Access Compliance Report

Public Rights-of-Way

(Curb Ramps)

Intersection ID: 51442	Main Street: TAMARRON_DR	Cross Street: KRISTENS_MARE_DR	Location: W
ADA ID: 5A797F2DDBC7	Ramp Type: PerpDiag	Initial Pass/Fail: Pass	Overall Compliance: No
Severity Score: 0			
Codes/Mitigation Info/Possible Solution		Field Measurements/Component Compliance

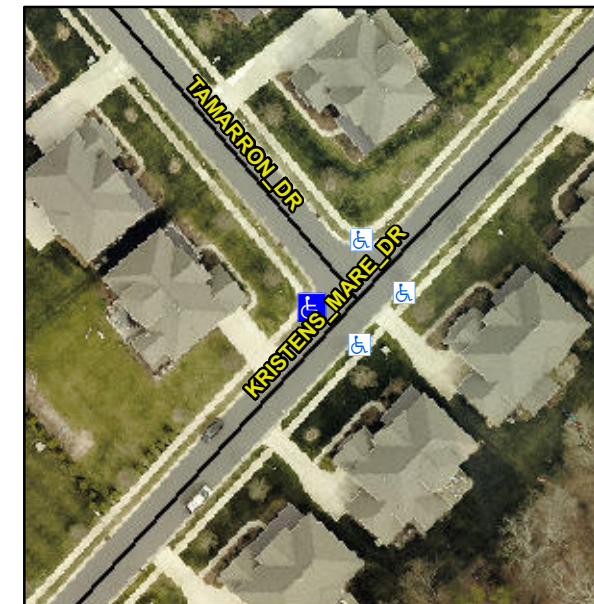
Not Found, R304.2.2-Perp, R304.3.2-Para, R305.2

Compliance	Description	Data	Compliance	Description	Data
N/A	Ramp Length (in)	47.0	Yes	Ramp Slope (%)	5.1
Yes	Ramp Width (in)	48.0	Yes	Ramp XSlope (%)	1.9
N/A	Flare Type LT	Sloped	N/A	Flare Type RT	N/A
N/A	Flare Slope LT (%)	5.3	Yes	Flare Slope RT (%)	1.1
N/A	Flare Traversable LT?	Yes	N/A	Flare Traversable RT?	Yes
Yes	Landing Length (in)	48.0	Yes	DWS Provided?	Yes
Yes	Landing Width (in)	48.0	Yes	DWS Contrast?	Yes
No	Landing Slope (%)	2.9	Yes	DWS Length (in)	24.0
Yes	Landing X Slope (%)	1.6	Yes	DWS Full Width?	Yes
N/A	Landing Curb? (Y/N)	No	No	DWS Offset (in)	4.0
N/A	Shared Landing?	No			
Yes	Gutter Ponding?	No	Yes	Gutter Slope (%)	0.1
Yes	Gutter Lip Ht (in)	0.0	Yes	Gutter X Slope (%)	1.1
N/A	Painted X Walk1?	No	N/A	Painted X Walk2?	No
	X Walk 1 Direction	To SE		X Walk 2 Direction	To NE
N/A	X Walk 1 Width (in)	N/A	N/A	X Walk 2 Width (in)	N/A
	X Walk 1 Slope (%)	1.2		X Walk 2 Slope (%)	1.6
	X Walk 1 X Slope (%)	1.2		X Walk 2 X Slope (%)	0.8

N/A	Ramp inside XWalk1?	N/A	N/A	Ramp inside XWalk2?	N/A
	Road Slope (%)	1.9	N/A	Clear Space?	Yes
	Road X Slope (%)	1.9	N/A	Clear Space to XWalk (in)	N/A
Yes	Any Obstructions?	No	Yes	Storm Grate/Utility Hazard?	No
	Obstruction Type			Storm Grate/Utility Type	
		N/A			N/A
			Yes	Surface Condition? (G/P)	Good

Remove & Replace Curb Ramp With Two New Directional Ramps or Equivalent.
